TYPE III –CONDITIONAL USE STAFF REPORT AND RECOMMENDATION

FILE NO.: CU 17-01: Conditional Use
SP 17-16: Site Plan and Design Review
VR 17-01: Variance

REQUEST: Conditional Use, Site Plan and Design Review and Variance application to add 28' X 64' modular building west of existing school site, for library and media center.

LOCATION: 19575 Sebastian Way, Oregon City, OR 97045
Clackamas County APN 3-2E-08DA-06400

EXTERIOR ELEVATIONS

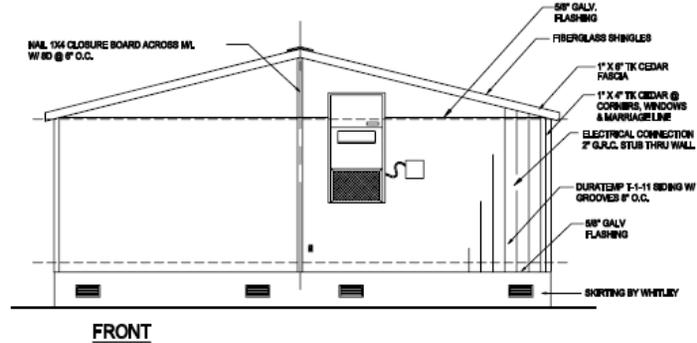
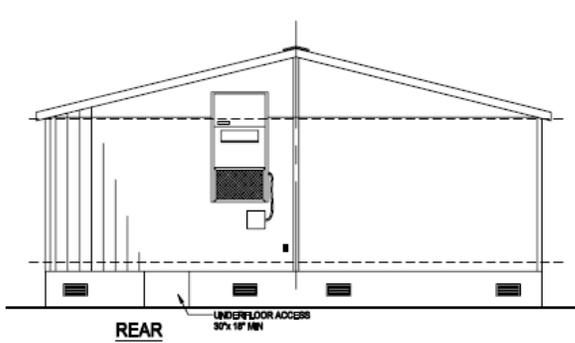
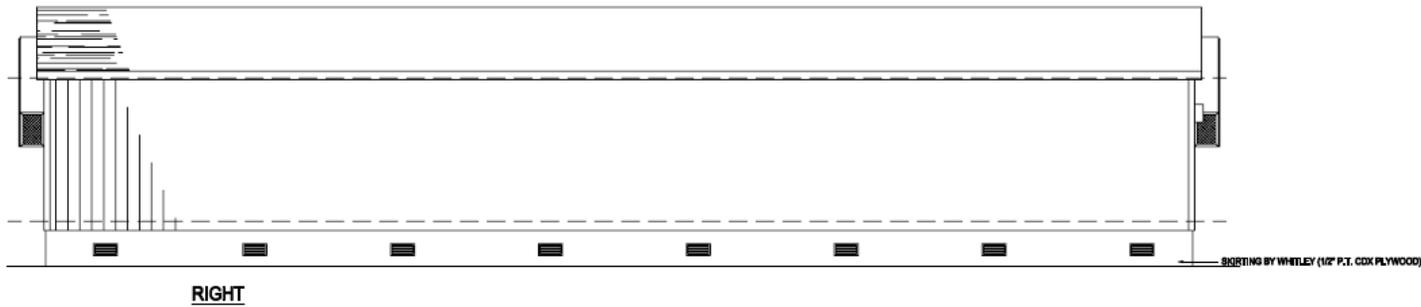
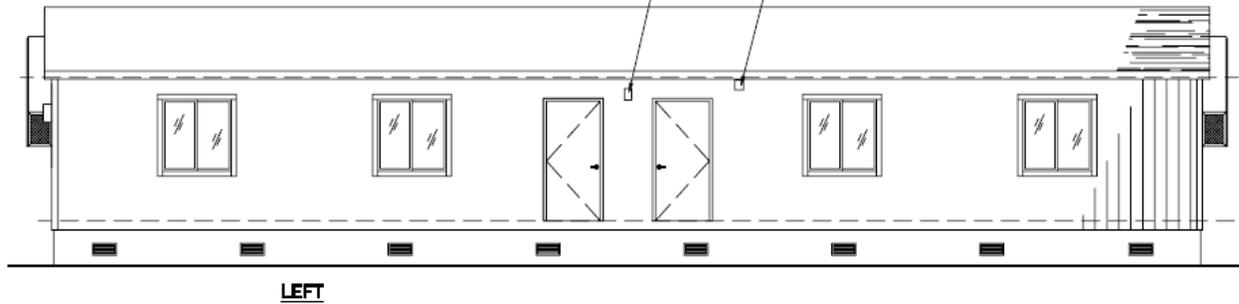
Finding: complies with condition. The applicant’s narrative and submitted building plans are in conflict. The narrative states that the exterior materials will consist of horizontal composite siding and fiberglass roofing shingles, but the applicant’s building exterior plans indicate the use of T-111 siding, a prohibited building material. The applicant shall not use T111 siding, but shall indicate the use if composite or wood siding on construction plans prior to issuance of a building permit. The site is not within a historic district and is not a designated historic structure. The applicant proposes to keep the chain link fencing that surrounds the site, in its current condition. Building and painted surfaces will be maintained for cleanliness and to prevent paint deterioration. **Staff has determined that it is possible, likely and reasonable that the applicant can meet this standard through the conditions of approval.**

Finding: complies as proposed. The proposed modular currently has one 40 watt fluorescent light with lexan cover with integral photo cell, per sheet A3 of the plans. The exterior lighting is proposed for the east exterior facade of the modular.

Finding: complies with condition. The 40-watt fluorescent bulb indicated on the plans did not indicate a foot-candle measurement. The applicant shall provide the necessary calculation converting the wattage to the foot-candles to assure compliance prior to issuance of a building permit. **Staff has determined that it is possible, likely and reasonable that the applicant can meet this standard through the conditions of approval.**

Finding: Complies with Condition. The applicant indicated that the proposed light source is a 40 watt fluorescent shielded by a lexan cover with integral photo cell, per sheet A3 of the plans, but did not indicate that a full-cutoff shield is used. A full-cutoff shield is one where no light is emitted above a 90-degree, horizontal plane from the base of the fixture is required. **Staff has determined that it is possible, likely and reasonable that the applicant can meet this standard through the Conditions of Approval.**

3. The applicant shall not use T111 siding, but shall indicate the use of composite or wood siding on all elevations and indicate this materials on construction plans. *(P)*
4. The applicant shall provide a revised landscaping plan with the statement that no mulch, bark chips, or similar materials shall be allowed at the time of landscape installation except under the canopy of shrubs and within two feet of the base of trees. *(P)*
5. The applicant shall provide a revised landscaping plan indicating that all on-site pedestrian walkways shall be hard surfaced, well-drained and at least five feet wide.

6. The applicant shall assure that lighting fixtures that exceed 13 watts include a full cut-off screen fixture in compliance with OCMC 17.62.065.D. *(P)*
7. The applicant shall provide documentation from a lighting specialist indicating the proposed development complies with OCMC 17.62.065. *(P)*
8. The applicant shall be required to provide a paint palette with at least two colors in order to provide additional visual relief and distinguish between wall planes and trim.
9. The applicant shall further mitigate the variance by proposing sufficient elements specified in OCMC 17.62.005.d.1 at the front of the property to improve pedestrian access and experience, such as:
 - a. Tables, benches or other approved seating area.
 - b. Cobbled, patterned or paved stone or enhanced concrete.
 - c. Pedestrian scale lighting.
 - d. Sculpture/public art.
 - e. Fountains/Water feature.
